## ARCHITECTURAL REVIEW BOARD WORK SESSION AGENDA

**Agenda Item:** APPLICATION FOR ALTERATION TO AN EXISTING STRUCTURE, ARB #26-006, 259 Sunset Park Drive, Herndon, Virginia, to consider an application for the installation of a new storefront and other minor site improvements, located on the south side of Spring Street west of the intersection with Sunset Park Drive and consists of an undetermined area of land

STAFF REPORT

**Agenda Item: ARB #26-006; Alteration to an Existing Structure; Fairfax County Tax Map 0164 21 0259, 259 Sunset Park Drive**

Figure 3: Elevation of proposed modifications to 259 Sunset Park Drive, including a new storefront system, door, accessibility ramp, and roof mounted mechanical units (detail from sheet A006).

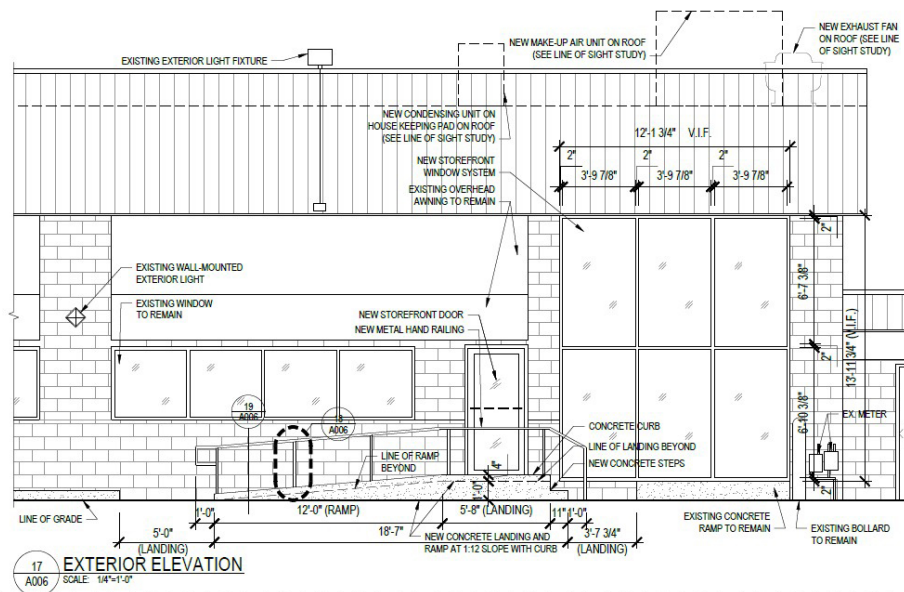
- The proposed RTUs will be taller than the existing parapet and should either be reduced in size in order to not be visible or additional screening should be added to cover the new RTUs (*Figure 3*). A sightline diagram is included in the associated materials; however, the ARB has generally required additional screening for RTUs if they extend above a building’s parapet, regardless of sightline analyses (see drawing 11, sheet A007 in the attached materials). The ARB should discuss appropriate screening for the RTUs as specified in the application during the work session.

Ramp Elevation + Sightline Diagram

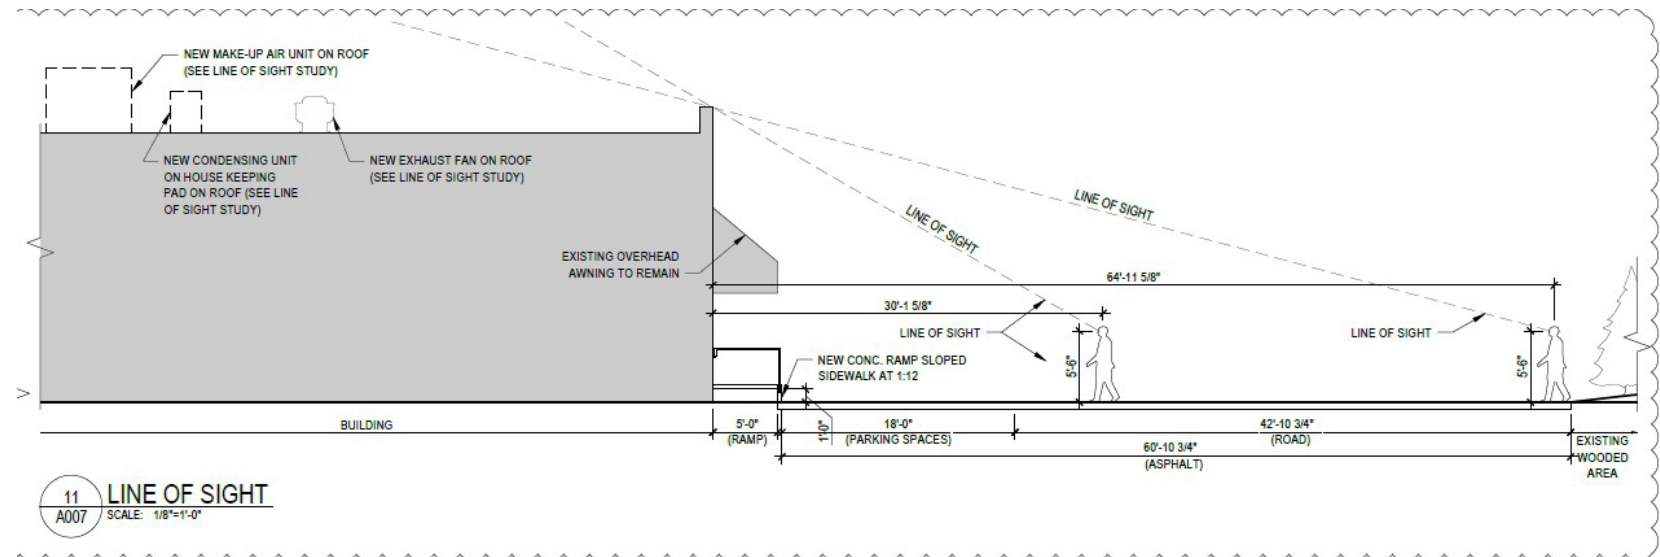
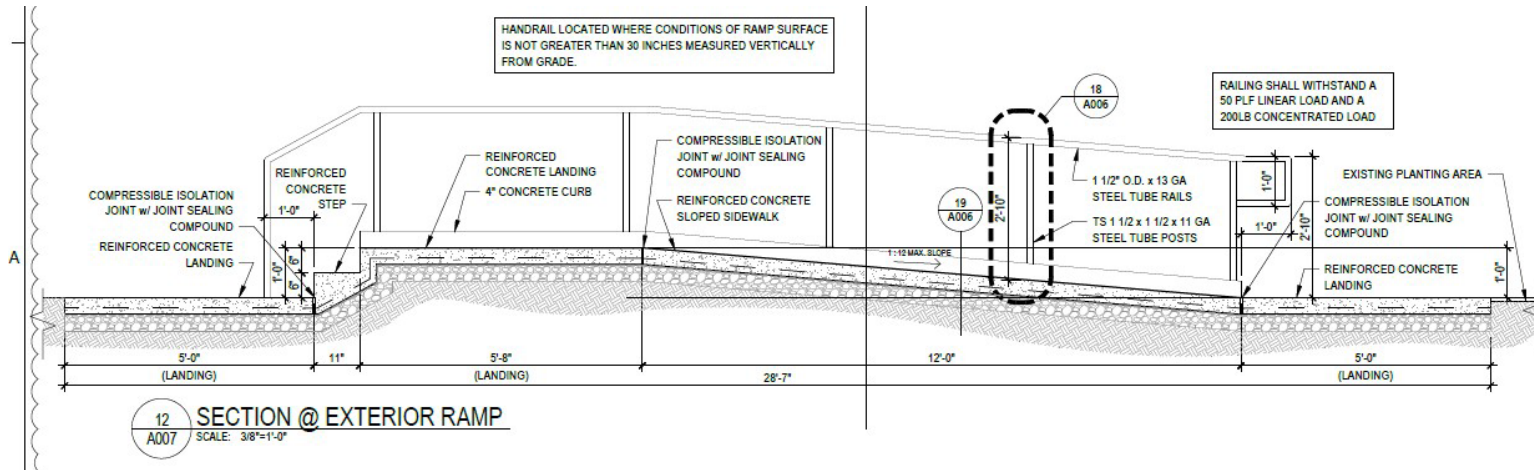
- Design aligns with the TRG plan to promote eclectic design elements
- The proposed design is consistent with the storefront of the adjacent property
- Proposed RTUs will be taller than the existing parapet
  - They should either be reduced in size in order to not be visible
  - **OR** additional screening should be added to cover the new RTUs
- Storefronts specifications are consistent with similar systems used throughout the town

- Staff are requesting:
  - Revised materials that show how RTUs will be appropriately screened

- Appropriate screening for the visible RTUs
- ARB comfort with staff review of revised RTUs and/or screening
